PUBLIC INTEREST TECNNICAL REVIEW FOR GROUNDWATER APPLICATIONS

ТО:	Water Rights Section		Date: <u>9/11/2025</u>
FROM:	Groundwater Section	Stacey Garrison	
SUBJECT:	Application <u>LL</u> [2012] _	Reviewer's Name Supersedes review of

A1. Application			
Applicant's Name:	Knife River Corporation	County: <u>Linn</u>	
Applicant(s) seek(s)	3.06 cfs from 1	well(s) in theWillamette	Basin,
	Mainstem Willamette River	subbasin	
Proposed use <u>Industrial/0</u>	Commercial/Fire Protection	Seasonality: <u>year-round</u>

Water-Level Measurements in Nearby Wells

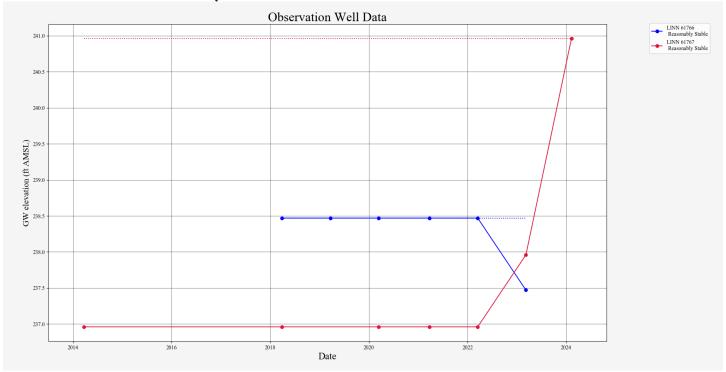
Well Log ID	POA Well #	Reference Level for Evaluation of Reasonable Stability (ft bls)	Rate Test	Magnitude Test	Water Levels Reasonably Stable
LINN 61766	N/A	8	Pass	Pass	Reasonably Stable
LINN 61767	N/A	5	Pass	Pass	Reasonably Stable
